N-63-4-3

STANDARDIZATION OF COMPONENTS
FOR
CD V-700, CD V-715, CD V-727

BY
THE VICTOREEN INSTRUMENT COMPANY
CLEVELAND, OHIO

The following three lists are recommended changes in the CD V-700, CD V-715, and CD V-727 specifications. Practically all of the recommendations are allied directly with standardization, but a few are items which merely require updating because they have escaped notice. This section only lists the actual changes. Discussion of the reasons for these recommendations is given in later sections of this report:

Figure 16

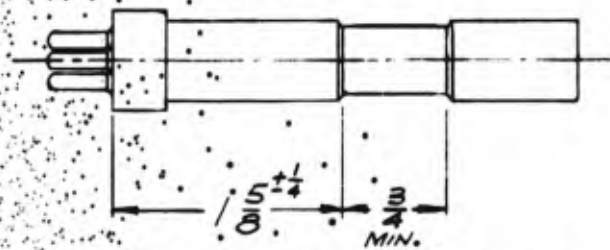
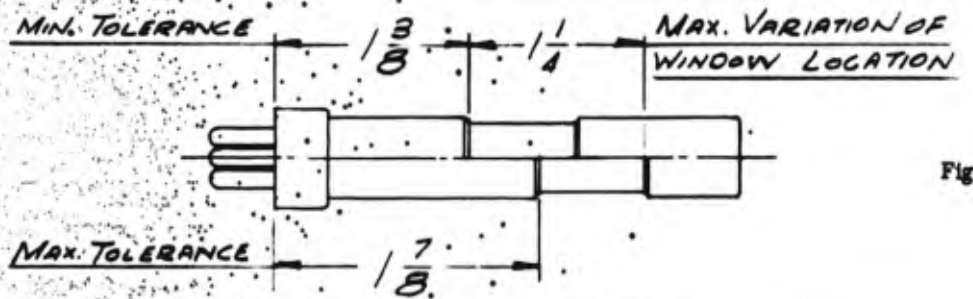
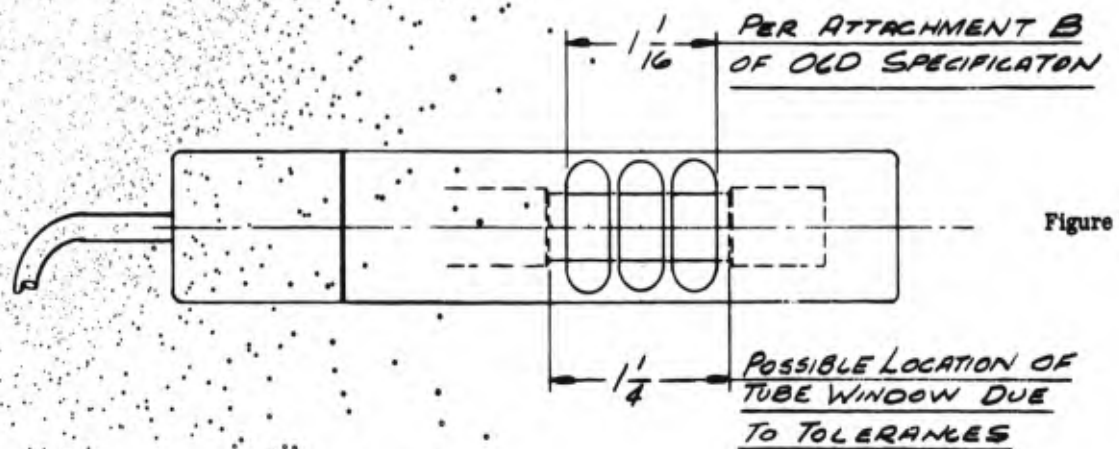
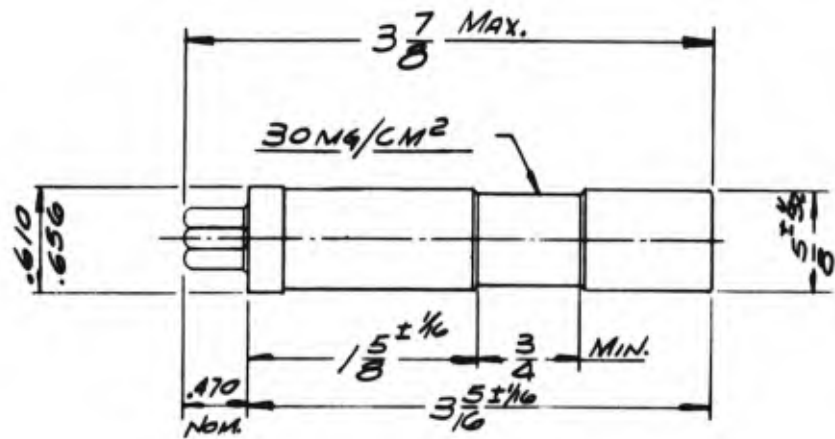
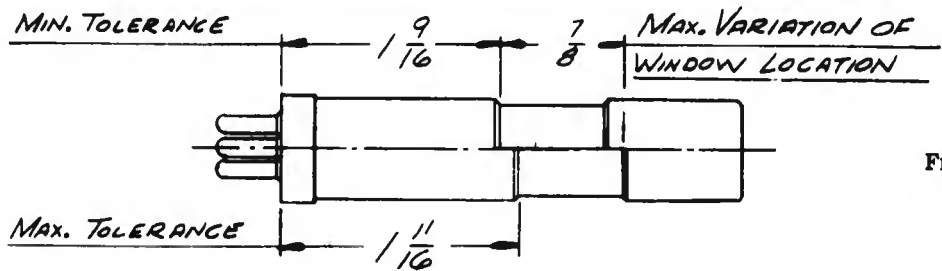
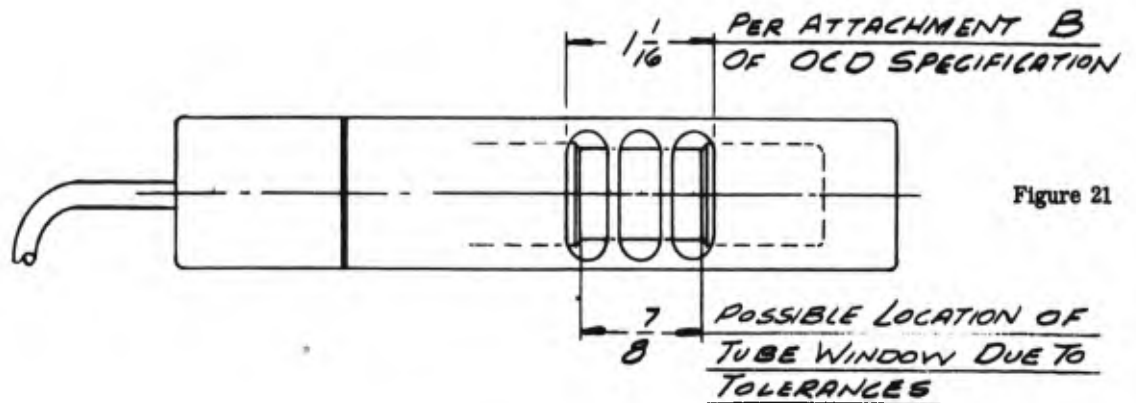
11. Page A-6. Revise drawing dimensions as follows: Change the $\pm 1/4$ tolerance on the $1-5/8$ dimension to $\pm 1/16$. Change the tube diameter dimension to $5/8 \pm 1/32$.

The geiger tube probe drawings, Figures 9 thru 13, along with the changes of tolerance on the window location of the geiger tube makes for a uniform assembly in which the geiger tube window and the probe window will always line up properly. Figures 16 thru 21 show the complete developmental story. Figure 16 is the present specified geiger tube. Figure 17 shows the variations in window position possible. Figure 18 shows the result on the combination of probe and tube as presently specified and found in the prototypes. Figures

19, 20 and 21 show the same items with the new proposed dimensions and tolerances.

Figure 22. Type 6993 Revised Test Procedure

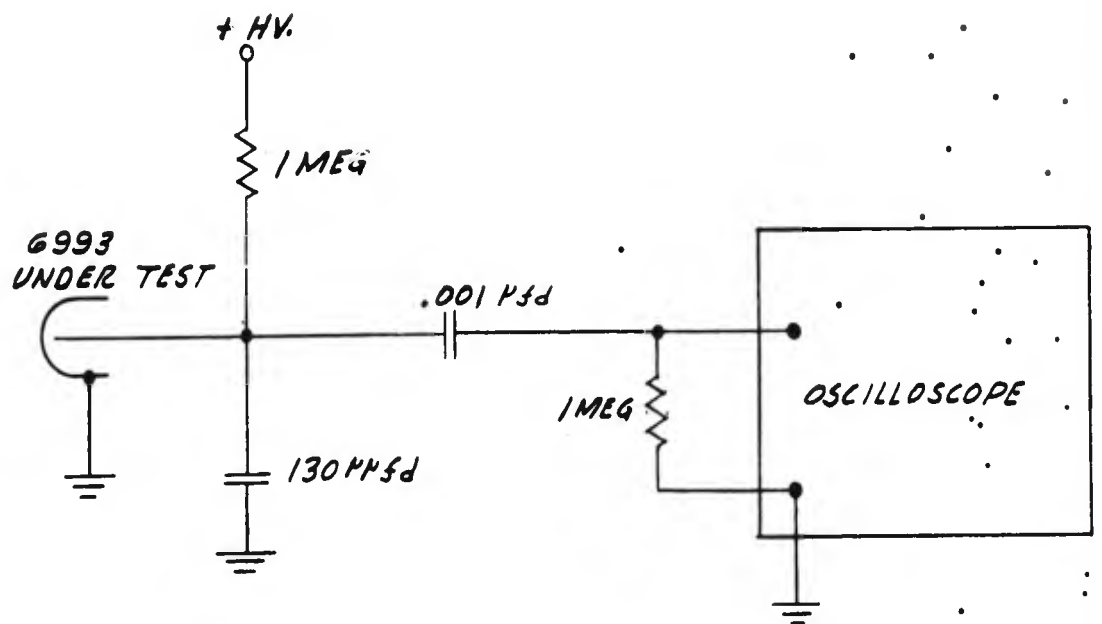
One additional specification modification on the geiger tube, which perhaps should be included but is not really mandatory, is a revision of the geiger tube test procedure. The circuit of Figure 22, is a suggested test circuit which can evaluate the geiger tube performance as related to the modern semiconductor circuits in which it is now used. The input impedance of these circuits is materially different from that of the older tube circuits for which the present tests were set up. With this test circuit the pulse output with a high voltage of 860 volts should not be less than 0.25 volts and the pulse width should not exceed 150 microseconds at 63% down from the pulse peak. These pulse heights and widths refer to the geiger tube only and have no bearing on the signal at the headphone connector. It is not recommended that the signal output for the headphone be changed.
